## To Our Valued Customers,

This note affects a specific revision of the iMX6 SoloX COM board (product number: EAC00244). The board is also sold as part of the iMX6 SoloX Developer's Kit (product number: EAK00245).

### Note about simultaneous Ethernet #0 and Parallel RGB interface usage

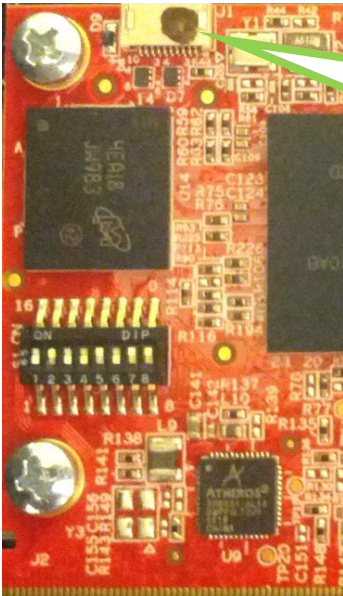
The affected revision of the iMX6 SoloX COM board is identified on the backside of the board, see picture below.

Boards marked with "WO-0634-1527" and "WO-0634-1533" are affected. These are boards called "iMX6SoloX COM board rev A". This text is also printed on the top side of the board. Boards that do not have this exact marking are not affected.

Most affected boards have been reworked. Only a few number of boards have been delivered and these boards need a small rework. The picture below illustrates how to identify if the board has been reworked, or not. If there is a black marking on the debug connector, like shown, the board has already been reworked and no further action is needed.

A black dot on the debug connector indicates that the board has already been reworked and is NOT affected by this note.

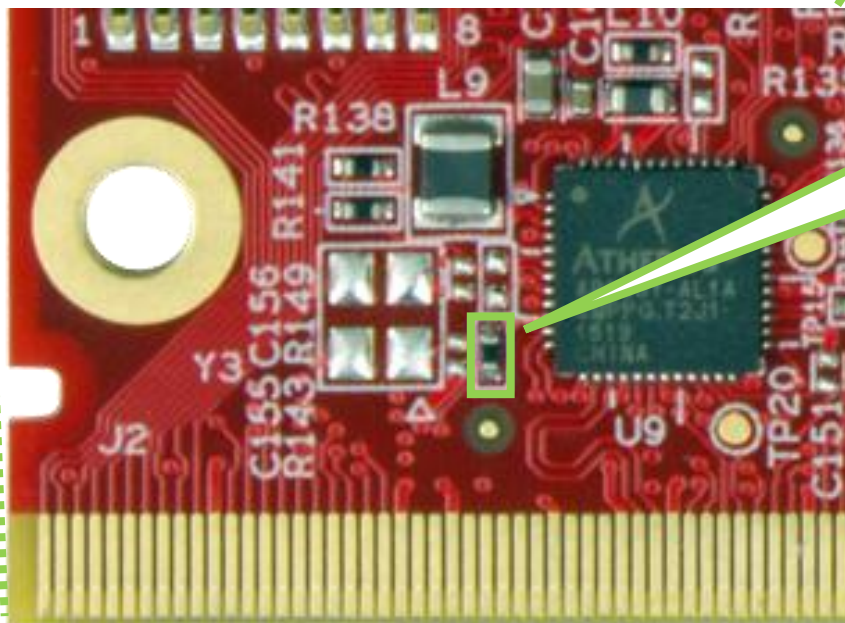
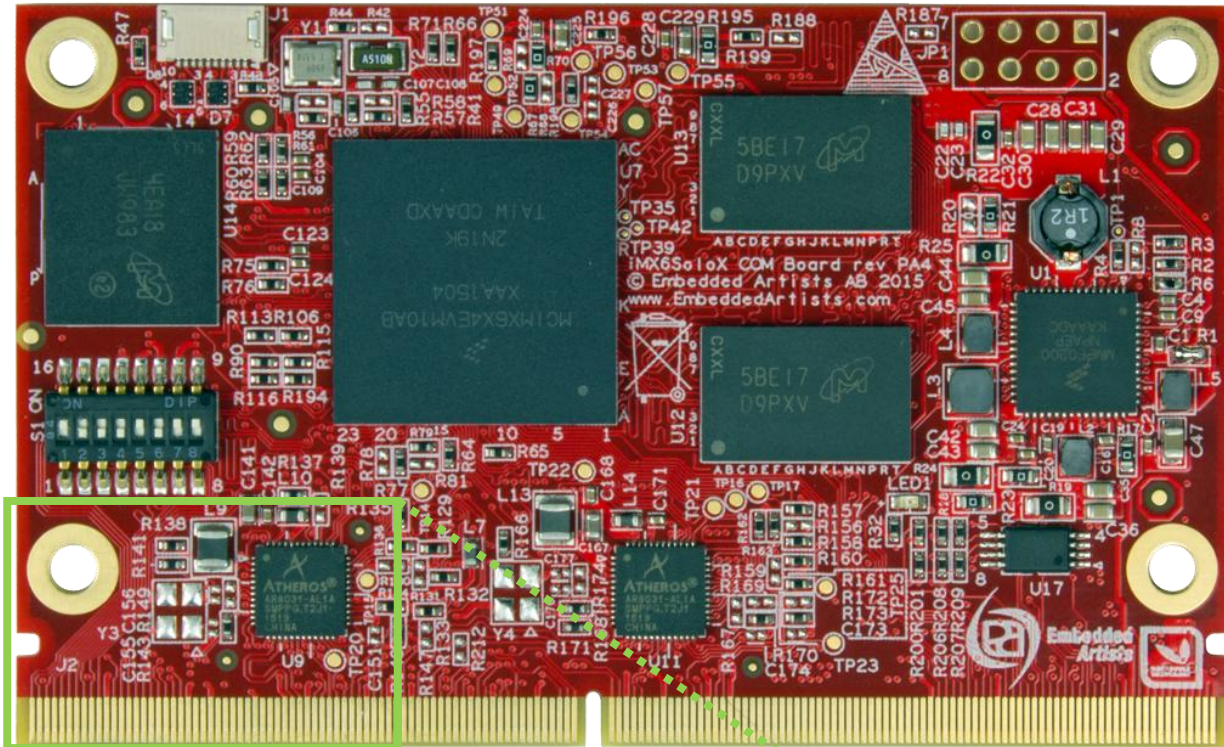
When the parallel RGB interface is active, under some circumstances a reference clock signal to Ethernet interface #0 is affected. This make it impossible to have reliable Ethernet communication on interface #0 (at the same time as the parallel RGB interface is active). The underlying reason is improper impedance matching of the Ethernet reference clock, causing ISI noise.

Replace R143 with a 20, 22 or 30 ohm resistor (0402-size). See pictures below to locate R143.

Replace R143 with  
20, 22 or 30 ohm  
resistor (0402-size).
